ZONING BOARD OF APPEALS
Regular Meeting Agenda
Wednesday August 5, 2026
6:30 P.M.

Variance/ZBA Review (ZBA26-0001) For Ypsilanti Township, Michigan

Applicant:	Brian Burkett, Aspire Architecture
Property Owner:	Doug Lampe
Address:	1680 Grove Road, Ypsilanti, MI 48197
Parcel:	K-11-14-300-006
Proposal:	House Addition/Remodel
Application Date:	February 4, 2026
ZBA Public Hearing	May 6, 2026
Zoning:	R-3, One-Family Residential
Action Requested:	Five (5) Variance Requests: 1. Height Variance – 29.4' (Approved 5/6) 2. # of Stories (3) – Postponed, Still Pending 3. Expansion of a nonconformity (principal structure within 100' Ford Lake setback) – Postponed, Still Pending 4. New Pool Building within the 100' lake setback, Postponed, withdrawn as applicant's resubmittal no longer requires variance 5. Patio Expansion into the 50' no disturbance setback and 100' from natural feature building setback. Postponed, 50' setback still needed for retaining walls although patio expansion no longer included

Proposed Remodel and Additions to the LAMPE RESIDENCE

Figure 6A & B: Top (Existing) and Bottom (Proposed)

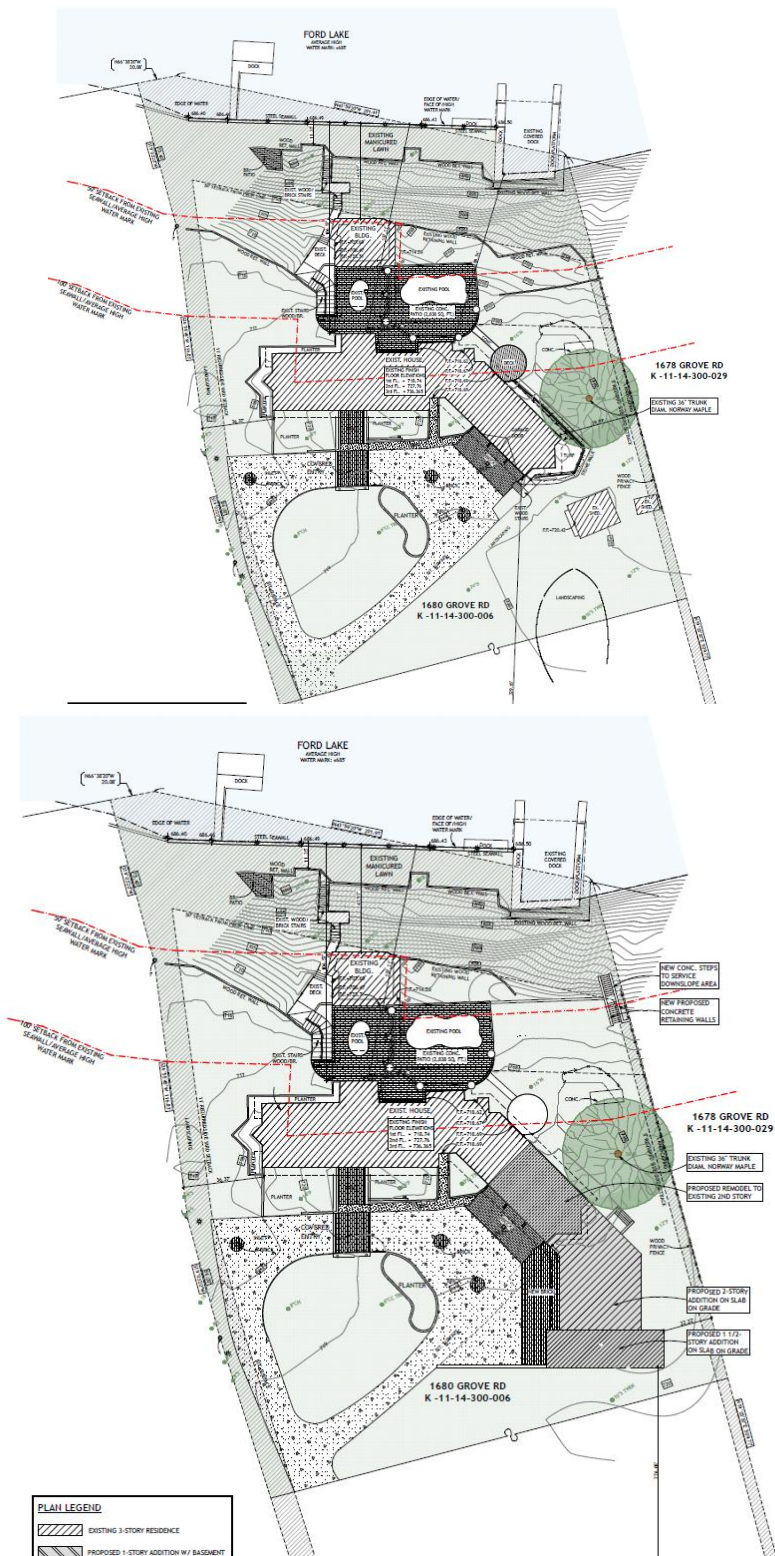
Variance #1 (Height): The proposed modification to a pitched roof as opposed to the current flat roof may be seen as necessary to maintain the structural integrity of the home with heavy snow and rains.

Variance #2 (# of Stories): The existing nonconformity remains, but staff concludes there's no exceptional circumstance with the property that restricts the home from keeping to the zoning code requirement.

Variance #3 (Expanding House within 100' of setback): Staff concludes that the existing home's location, which at one time was conforming to the zoning code, could not be expanded without encroaching into the setback.

REFERENCE NORTH
SITE PLAN - PROPOSED
1" = 20'

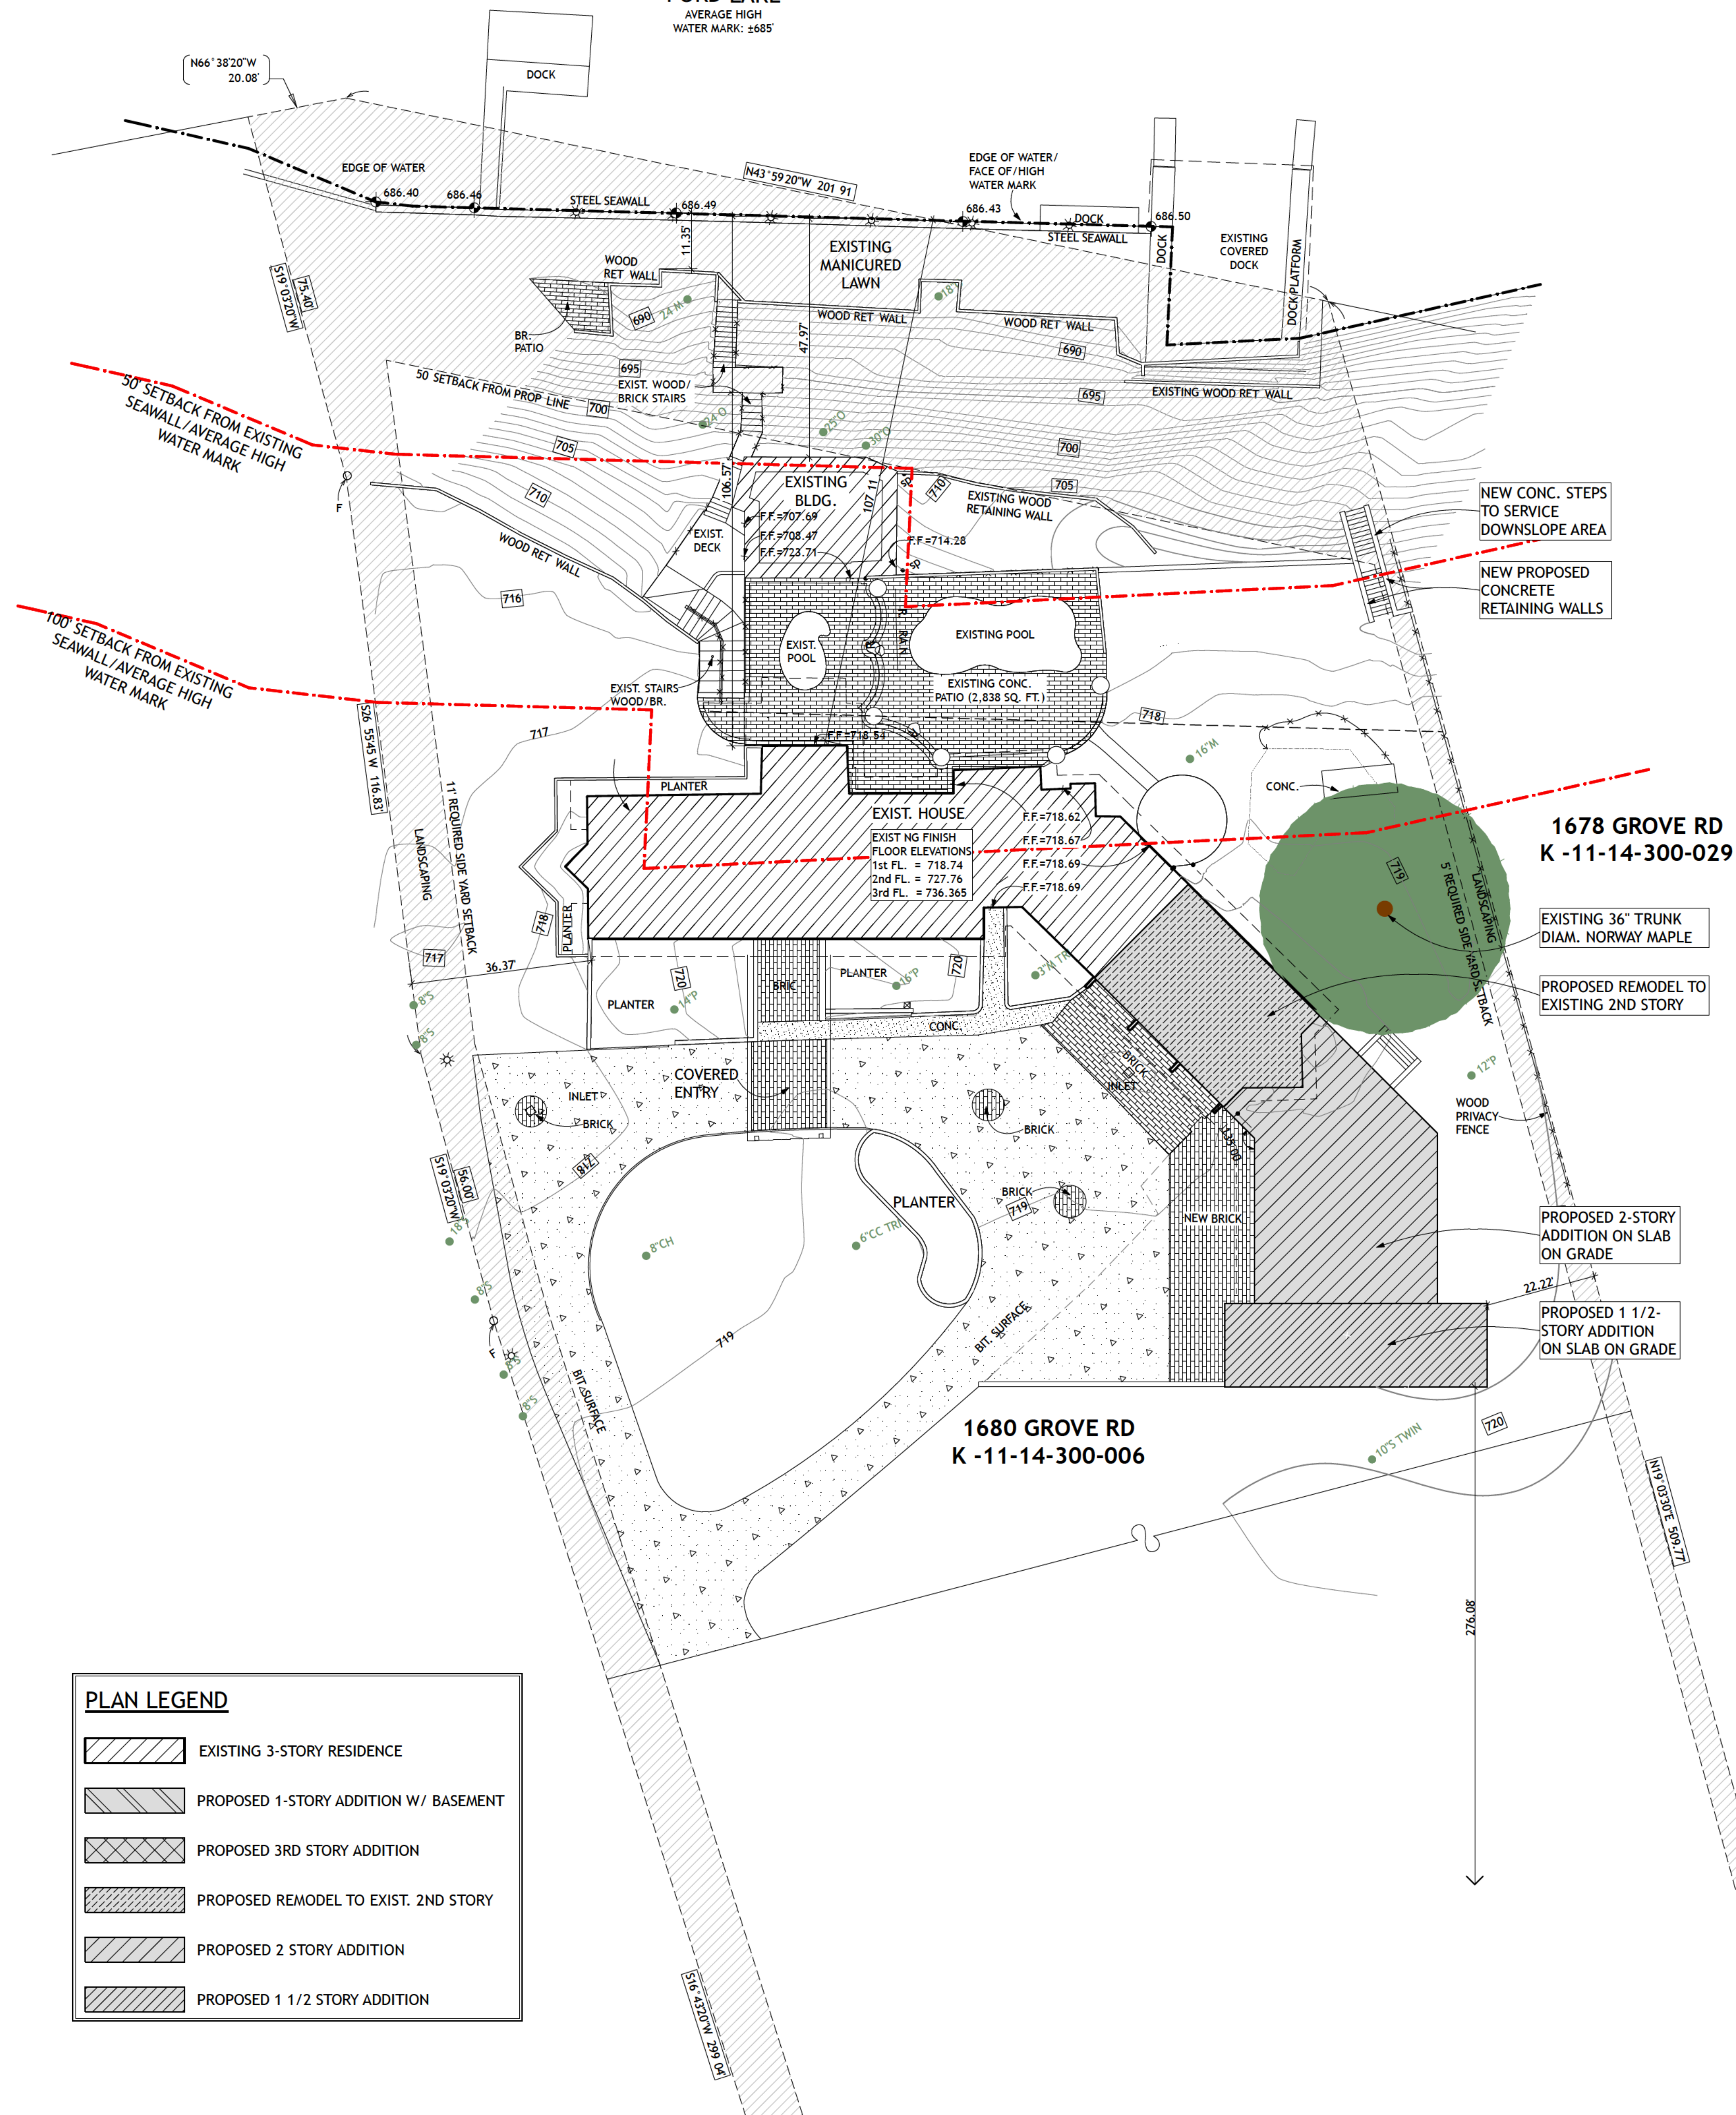
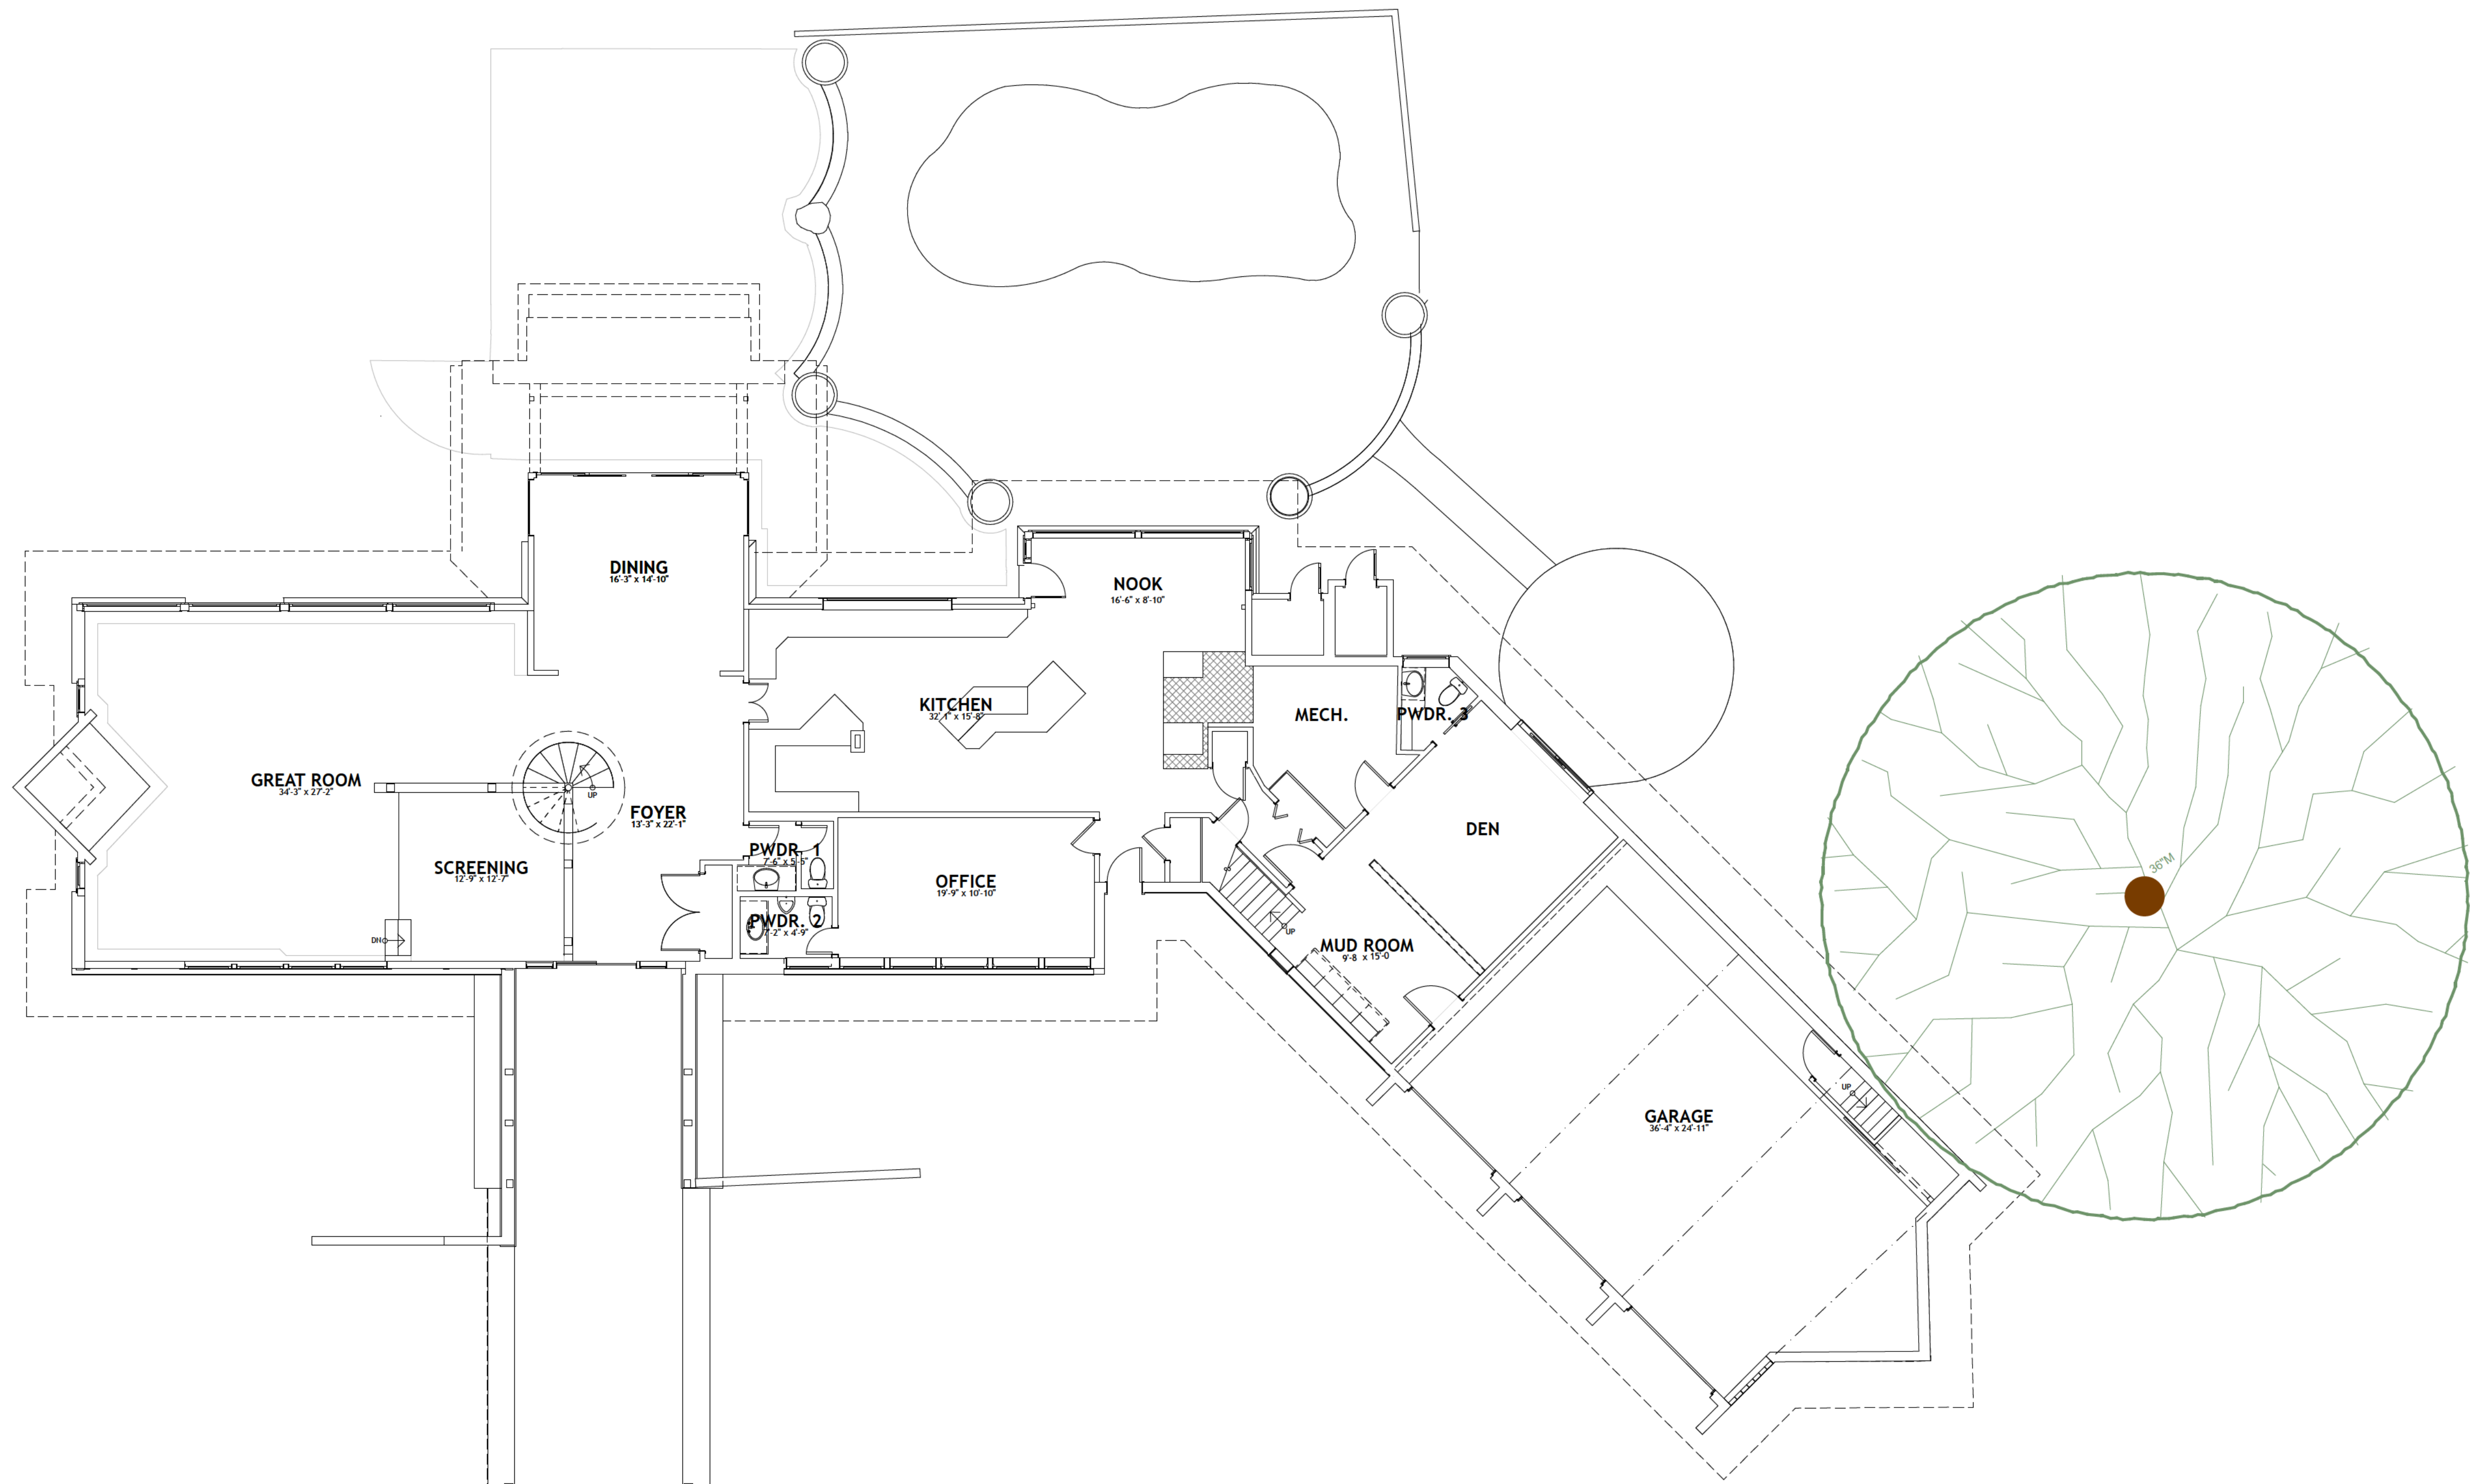
Variance #5 (50' No Disturbance Setback) While the new request is to only replace and create a retaining wall, there is an approximate 20' difference in elevation, which may be considered the need for a retaining wall.

Variance #5 (50' No Disturbance Setback): Staff notes that some of the grading in this requested variance is required by the steep slope between the pool area (and proposed patio) and the lake-bed below, which is approximately 20' in elevation that may seen to meet this criteria.

Variance #5: (50' No Disturbance Setback): While the existing retaining wall may have been self-created by previous property owners, the need to replace it may be considered justified and necessary to prevent erosion as the property and

Variance #2 - #5: Staff concludes the applicant has revised the plans to include more expansion within the principal building and less around Ford Lake and Fofrd Lake setbacks to mitigate the setback variance requests. The Zoning Board of Appeals should evaluate if these variance requests are the minimum necessary as building expansions outside of the setbacks and requirements could be achieved for reasonable use of the property.
